Control Message Update v5

Dave Olsen 7/06/2012

Control Stream Format

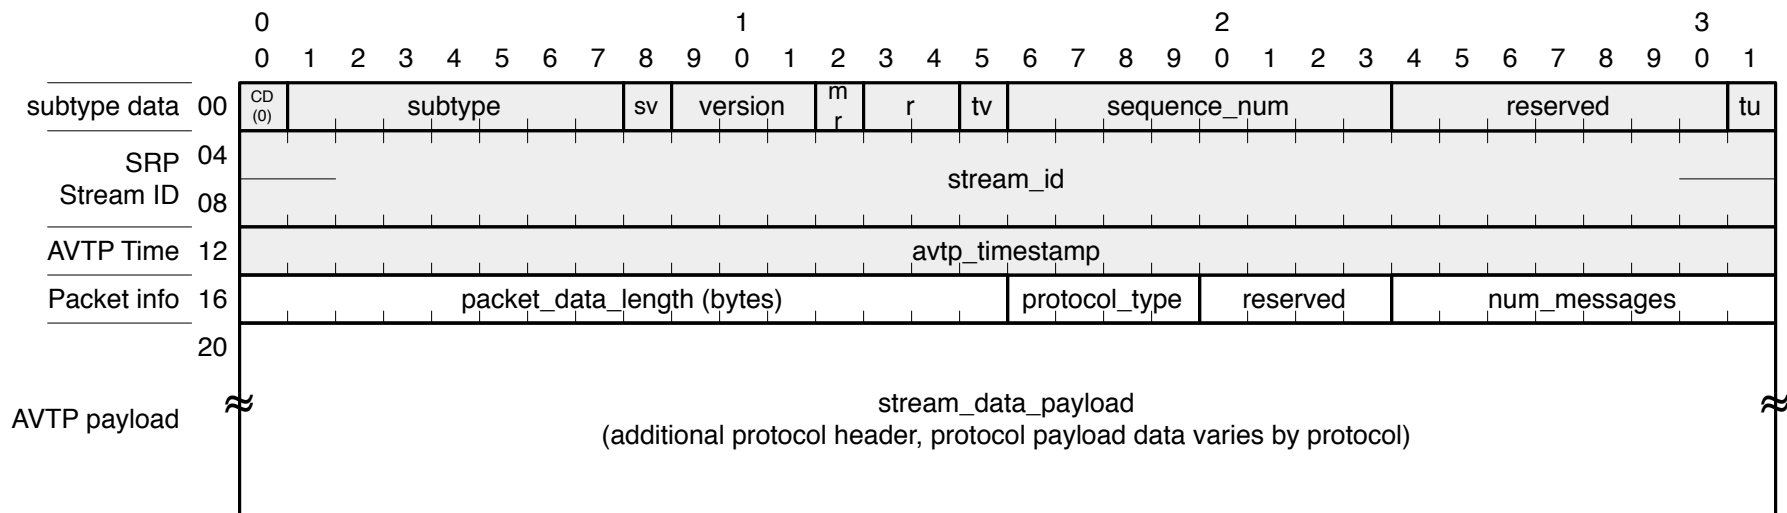
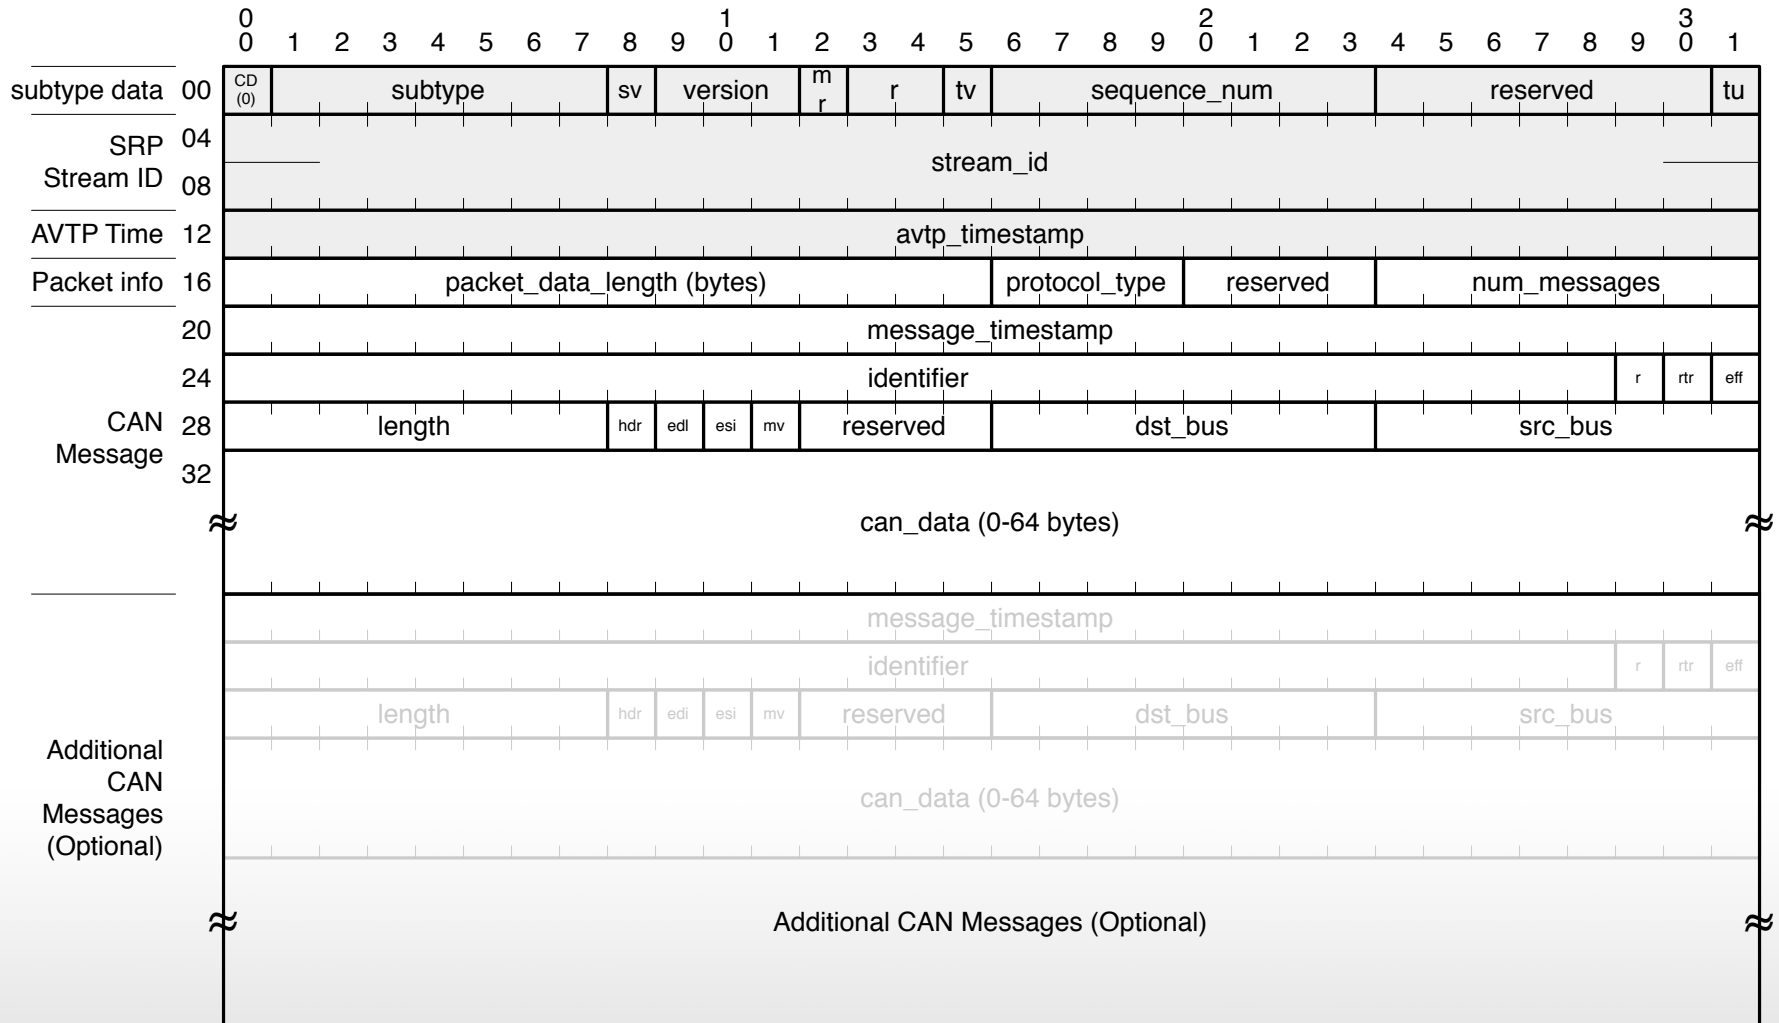
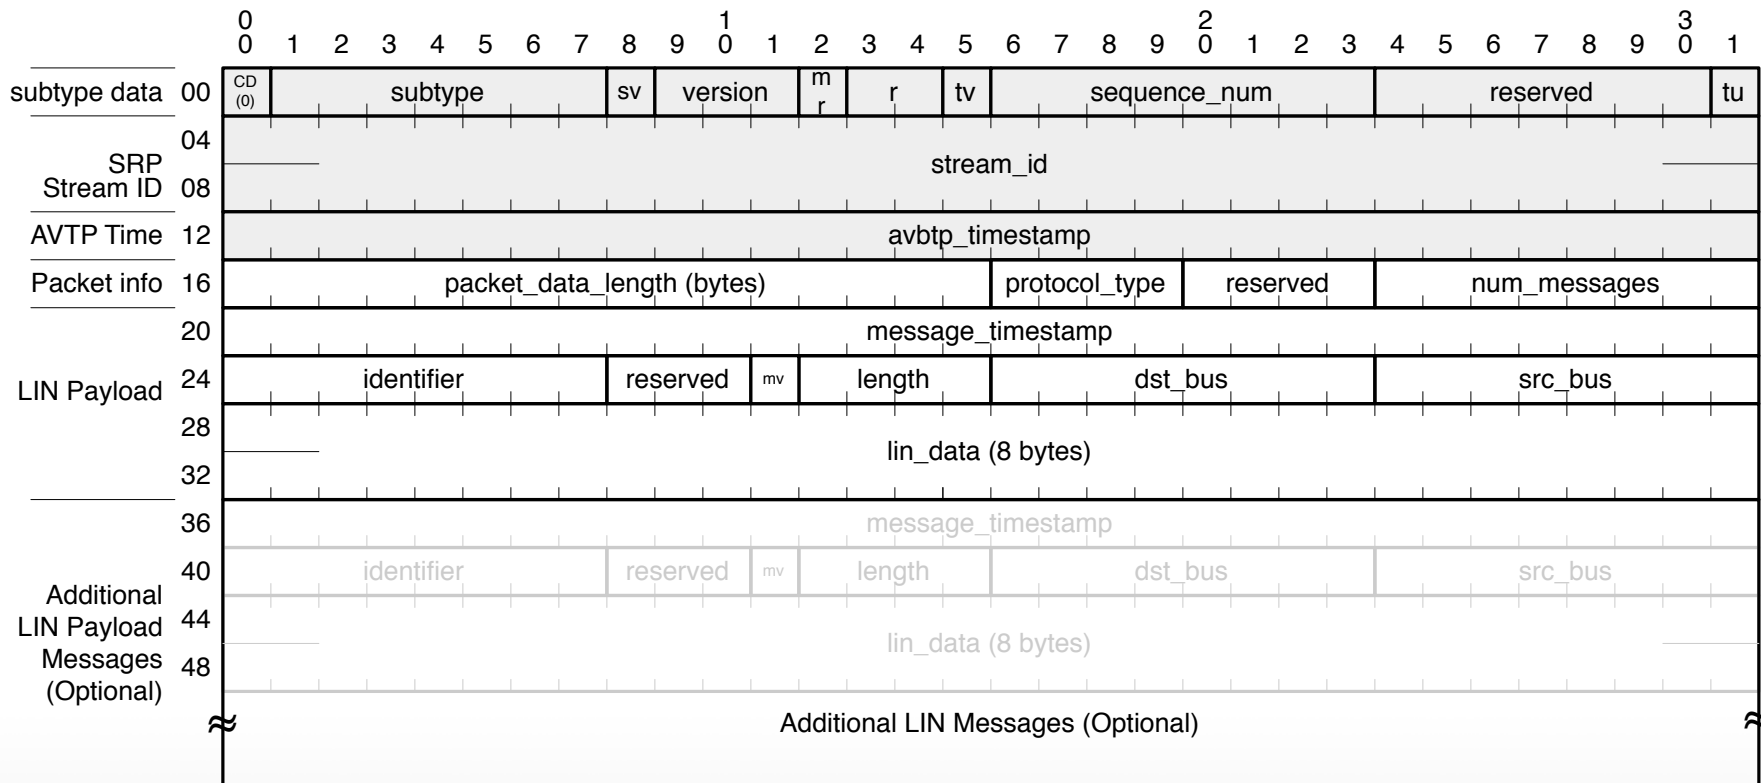
-
- **New CAN Message Format**
 - **CAN Extended and Base formats combined to single new format**
 - **Other formats normalized to match style**
 - **FlexRay format still needs review for unneeded bits**
